HISTORIC LANDMARK COMMISSION
STAFF REPORT

Petition 470-07-41 Oettli Single-family Dwelling
New Construction
768 East Fifth Avenue in the Avenues Historic District
February 20, 2008

Proposed Oettli Residence 766 East 5th Avenue, Salt Lake City, Utah

MAIN FLOOR

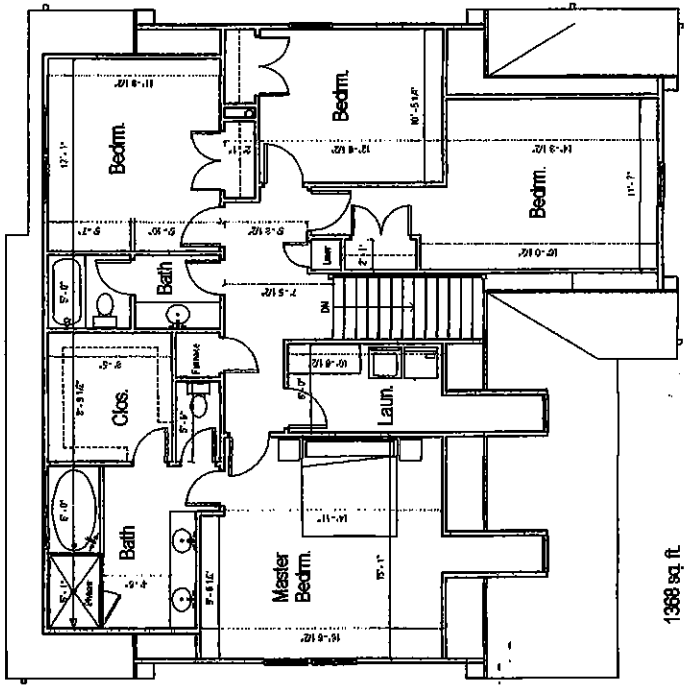
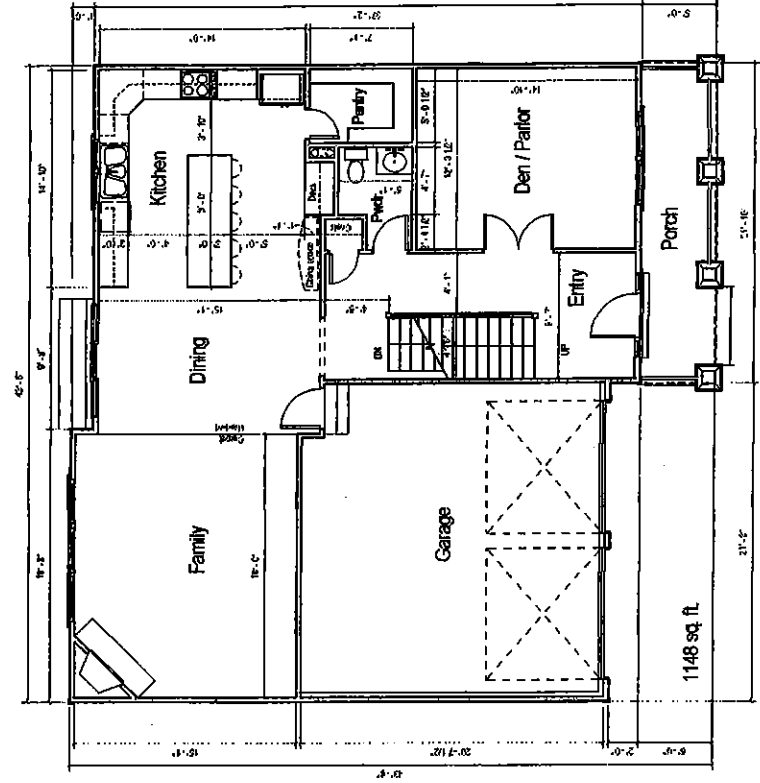
- The garage wall plane has been set back two feet (2') from the front of the building. A five foot (5') deep porch element extends across the front façade protecting the entrance to the house.

- The front facing gable has been relocated to cover the main porch element such that the porch and pedestrian entry become the dominant features. The garage is located under a roof line that runs parallel to the street with a wide eave overhang, boxed with brackets further minimizing the appearance of the attached garage.
